# Access Compliance Report

## Public Rights-of-Way

### (Curb Ramps)

Intersection ID: 53421	Main Street: ARDREY_KELL_RD	Cross Street: N/A	Location: NW
ADA ID: BB62EBF6E9F5	Ramp Type: Perp	Initial Pass/Fail: Fail	Overall Compliance: No
		Severity Score: 12.5

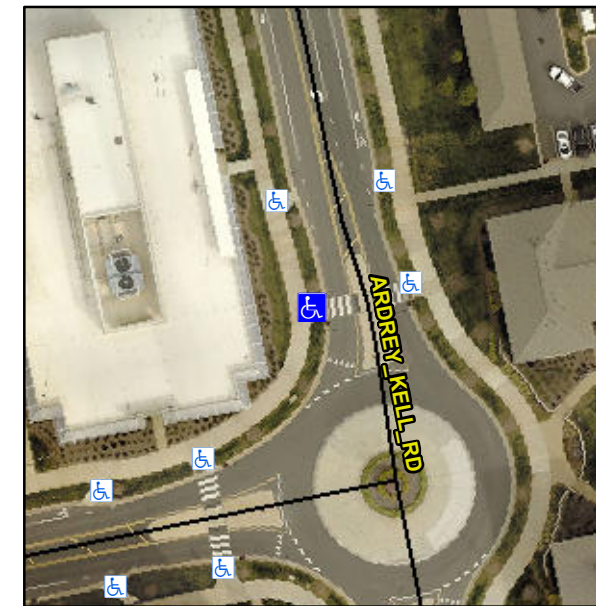
Compliance	Description	Data	Compliance	Description	Data
N/A	Ramp Length (in)	95.0	No	Ramp Slope (%)	9.1
Yes	Ramp Width (in)	118.0	Yes	Ramp XSlope (%)	0.5
N/A	Flare Type LT	N/A	N/A	Flare Type RT	N/A
N/A	Flare Slope LT (%)	N/A	N/A	Flare Slope RT (%)	N/A
N/A	Flare Traversable LT?	N/A	N/A	Flare Traversable RT?	N/A
N/A	Landing Length (in)	N/A	N/A	DWS Provided?	N/A
N/A	Landing Width (in)	N/A	N/A	DWS Contrast?	N/A
N/A	Landing Slope (%)	N/A	N/A	DWS Length (in)	N/A
N/A	Landing X Slope (%)	N/A	N/A	DWS Full Width?	N/A
N/A	Landing Curb? (Y/N)	N/A	N/A	DWS Offset (in)	N/A
N/A	Shared Landing?	N/A			
N/A	Gutter Ponding?	N/A	N/A	Gutter Slope (%)	N/A
N/A	Gutter Lip Ht (in)	N/A	N/A	Gutter X Slope (%)	N/A
N/A	Painted X Walk1?	Yes	N/A	Painted X Walk2?	N/A
	X Walk 1 Direction	To E		X Walk 2 Direction	N/A
N/A	X Walk 1 Width (in)	120.0	N/A	X Walk 2 Width (in)	N/A
	X Walk 1 Slope (%)	2.5		X Walk 2 Slope (%)	N/A
	X Walk 1 X Slope (%)	0.5		X Walk 2 X Slope (%)	N/A

**Remove & Replace Entire Ramp.**

**R304.2.2**
